International Code Council

**ICC 500-2023 edition**  
**Public Input Agenda**  
**based on input received**  
**on 2020 edition of the**  
**ICC 500 Standard**

**For February, 2023**  
**Meeting – Teleconference**

**FIGURE 803.9.3(1)**  
**MASONRY UNIT WALL ASSEMBLIES AND ROOF ASSEMBLIES**

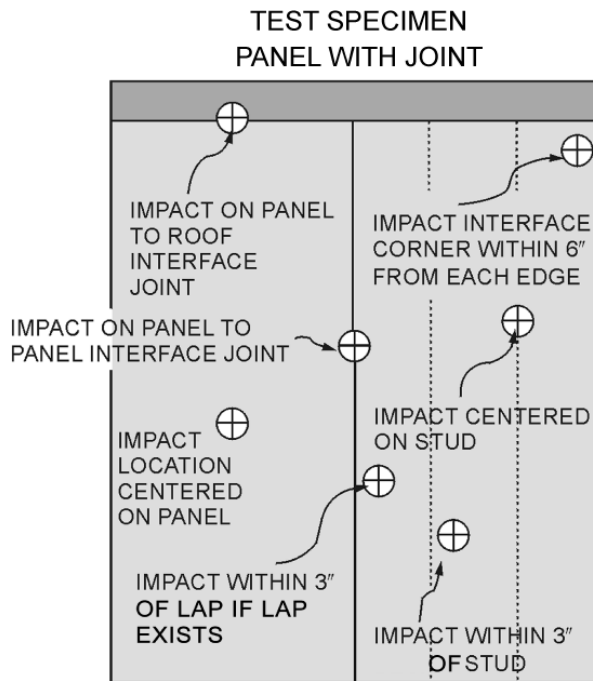
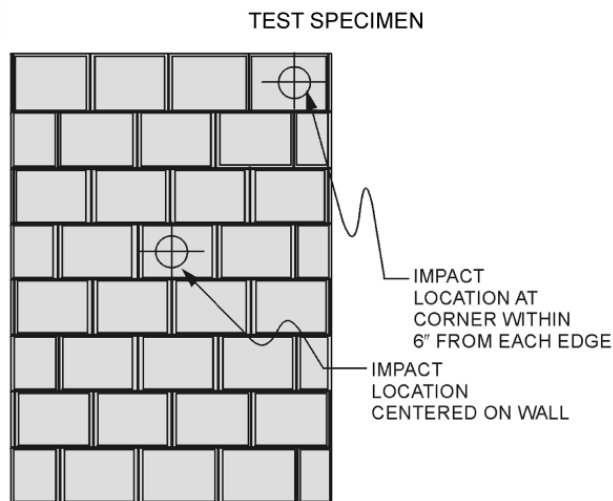
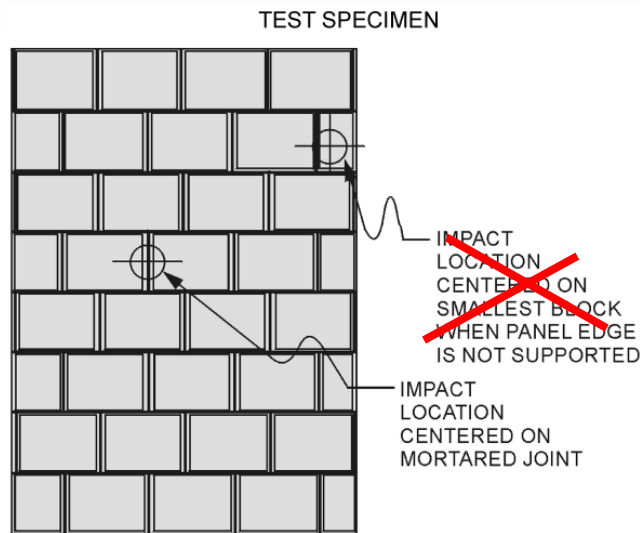
**Reason:** The smallest block impact does not appear in the text requirements. As the figures are informational only, the figure should be revised to match the text requirements.

**FIGURE 803.9.4.3SECTIONAL DOOR ASSEMBLIES**

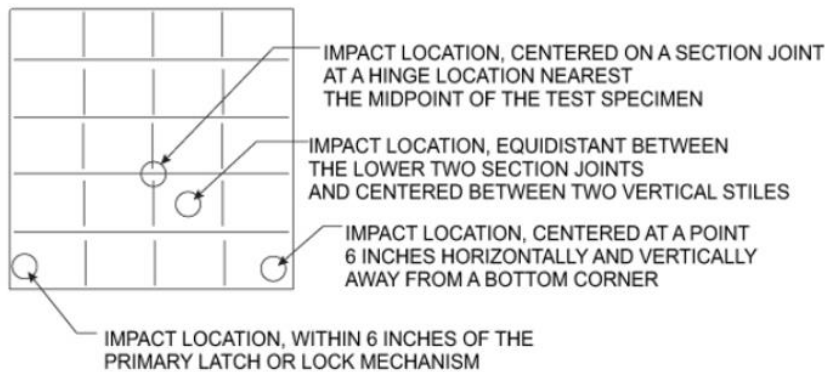
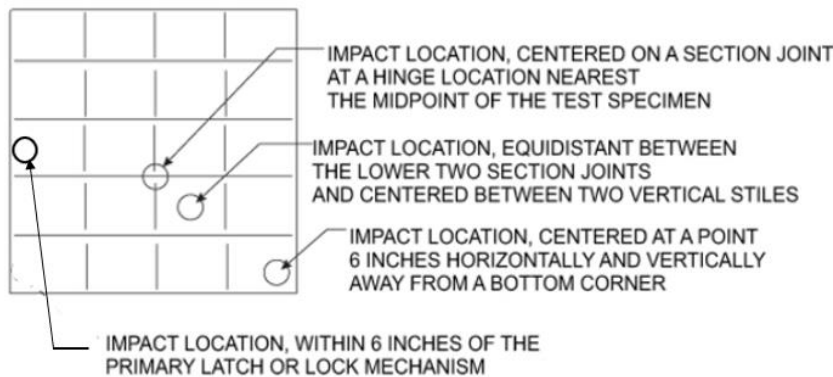
**803.9.4.3 Sectional door assemblies.** For sectional door assemblies, the door shall be impacted centered on a section joint at a hinge location nearest the midpoint of the test specimen, equidistant between the lower two section joints and centered between two vertical stiles, centered at a point 6 inches horizontally and vertically away from a at one bottom corner, and within 6 inches (152 mm) of the primary latch or lock mechanism as shown. See example in Figure 803.9.4.3.

**Reason:** Cleanup and clarity of text to align with Figure. There should not be variation in the text between the section language and the figure.

**FIGURE 803.9.5(1)**  
WINDOW ASSEMBLIES AND OTHER GLAZED OPENINGS

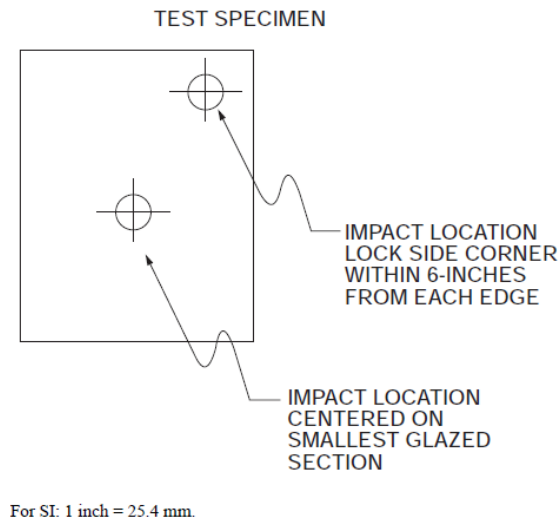
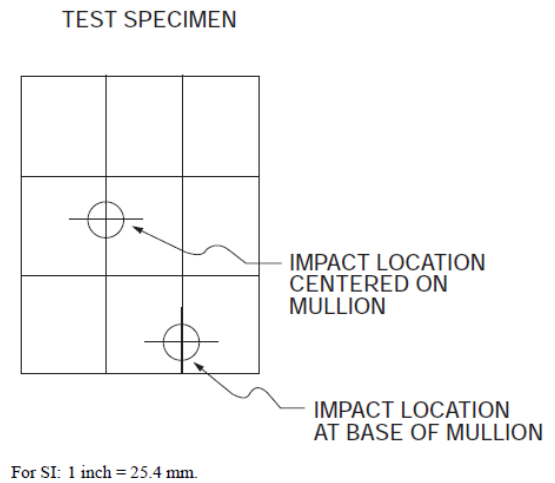
**803.9.5 Window assemblies and other glazed openings.** All window assemblies and other glazed openings shall be impacted in the center of the smallest glazed section, and at the lock side corner, or one interface corner, within 6 inches from each edge as applicable one interface corner as detailed in Figure 803.9.5(1). Where interior mullions or other glazed section joints ~~and/or latches~~ are present, the assembly shall be impacted centered on the mullion and at base of mullion ~~additional impacts shall be applied on these features~~ as shown in Figure 803.9.5(2). Interface hinge joints and primary latches, where present, shall be impacted as shown in Figure 803.9.4.1(2) on an additional specimen.

**Reason:** Cleanup and clarity of text to align with Figure. There should not be variation in the text between the section language and the figure.

**Figure 803.9.5(1) 803.9.5.1**  
**WINDOW ASSEMBLIES AND OTHER GLAZED OPENINGS**  
(Note: Change 'lock' to 'lock/latch' in note)

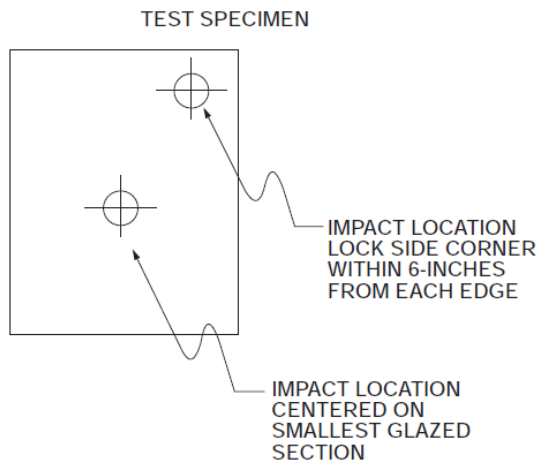
**803.9.5.1 Glazed openings.** Glazed openings shall be impacted in the center of the smallest glazed section, and at one lock/latch side corner where a lock/latch is provided, or one interface corner where no lock/latch is provided, within 6 inches from each edge. See example as detailed in Figure 803.9.5(1)-803.9.5.1.

**Figure 803.9.5(2) 803.9.5.2**  
**WINDOW ASSEMBLIES AND OTHER GLAZED OPENINGS WITH MULLIONS**

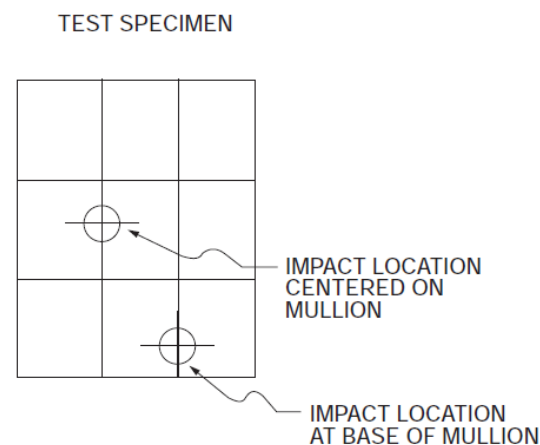
**803.9.5.2 Mullions and mullion connections.** Where interior mullions or other glazed section joints and/or latches are present, ~~the assembly~~ each mullion design and mullion connection design shall be impacted ~~centered on~~ at the center of the mullion and at base of mullion additional impacts shall be applied on these features, and at the end of the *mullion* within 6 inches of the *mullion* joint. See example as shown in Figure 803.9.5(2) **803.9.5.2.** Where multiple identical instances of a *mullion* design or *mullion* connection design are present, the worst-case instances shall be selected by the test laboratory for impact testing.

**FIGURE 803.9.6(2)  
LOUVER ASSEMBLIES**

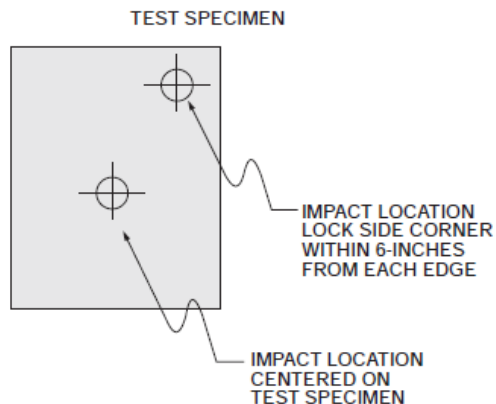
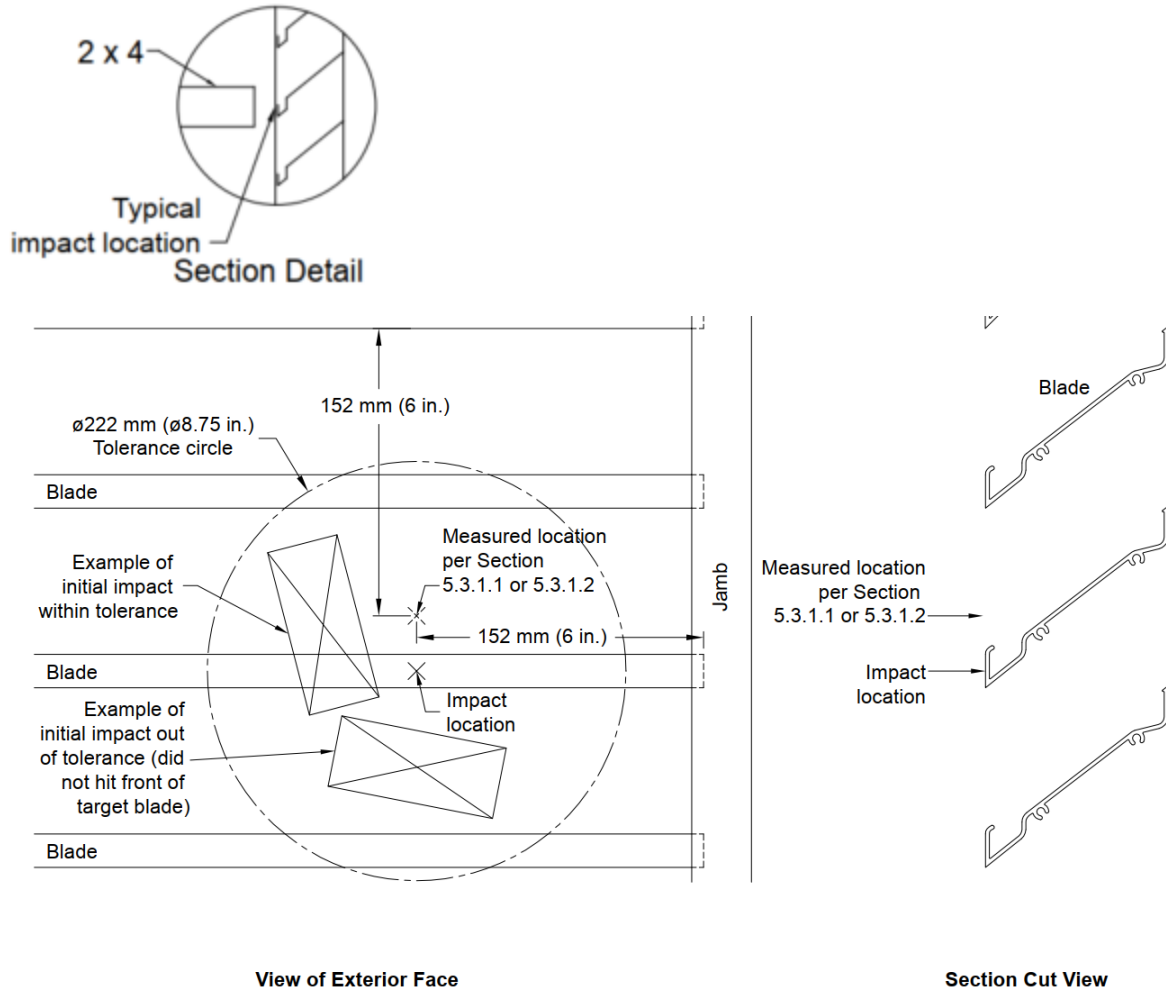
**803.9.6 Louver assemblies.** Louver assembly test specimens shall be impacted at the center of the unsupported span on each unique louver section, and at one interface corner of each unique louver section. See example in Figure 803.9.6(1). The exterior edge of the louver blade shall be impacted by a portion of the leading face of the test missile. See example in Figure 803.9.6(2).

**Reason:** Specifics are needed for louvers.

FIGURE 803.9.7.1  
ALCOVE OR BAFFLED STORM SHELTER ENTRY SYSTEMS FOR WHICH TESTING IS REQUIRED

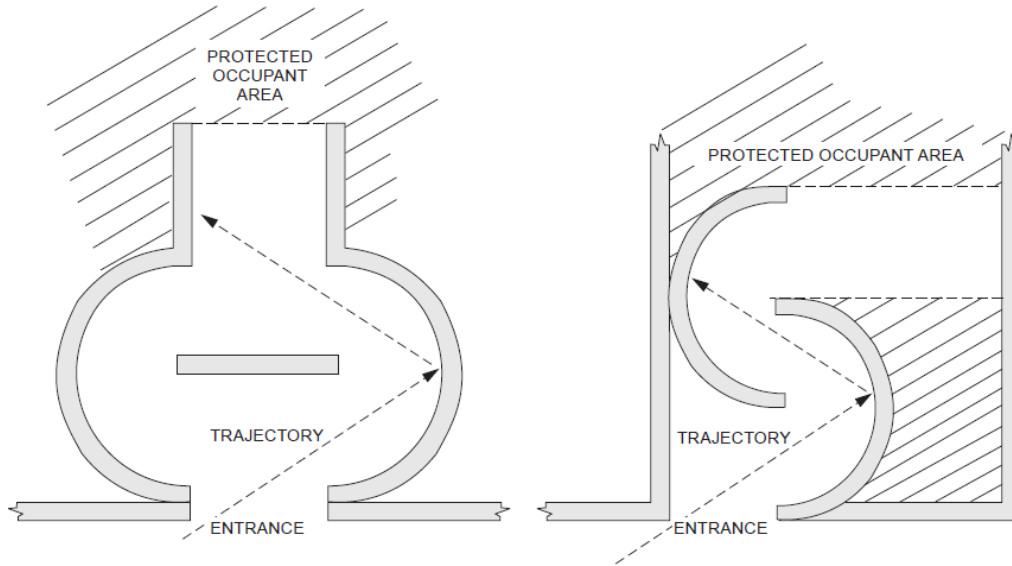
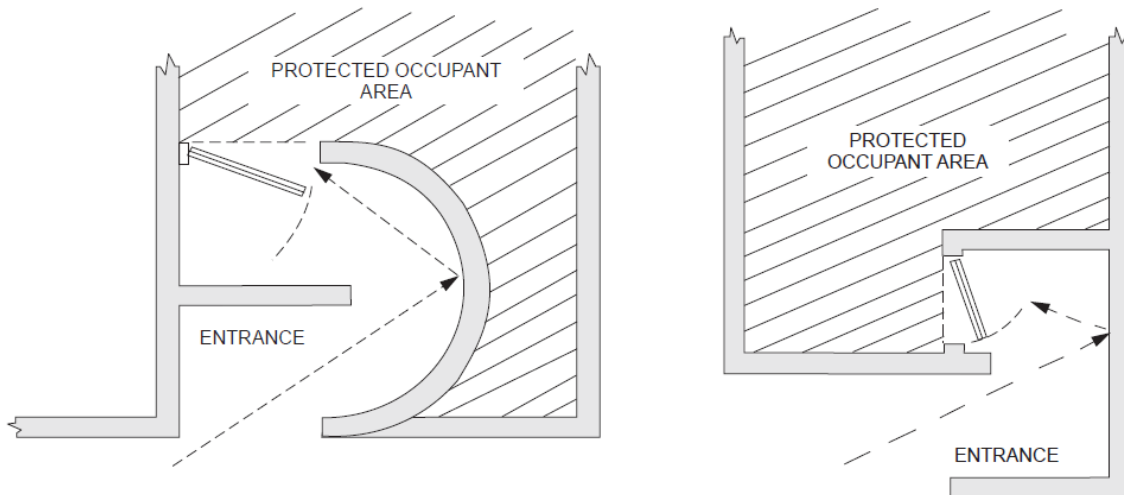
**Reason:** Figure 803.9.7.1 does not depict a rebound impact on a door, which is the scope of item 2 and Section 803.9.7.2.

FIGURE 803.9.7.3  
DOOR ASSEMBLIES SUBJECT TO REBOUND IMPACT

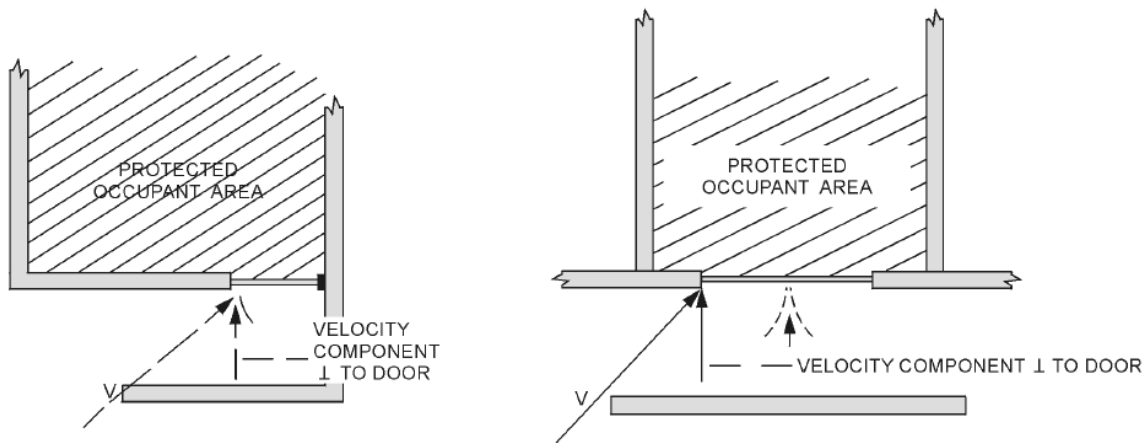
**803.9.7.3 Door assemblies subject to first impact.** Where a first-strike angle missile will impact on the door assembly (see Figure 803.9.7.3 for an example) the door assembly shall meet the wind load requirements of Section 306.3, the fire-resistance requirements of Section 603, and ~~meets~~ meet one of the following debris impact criteria:
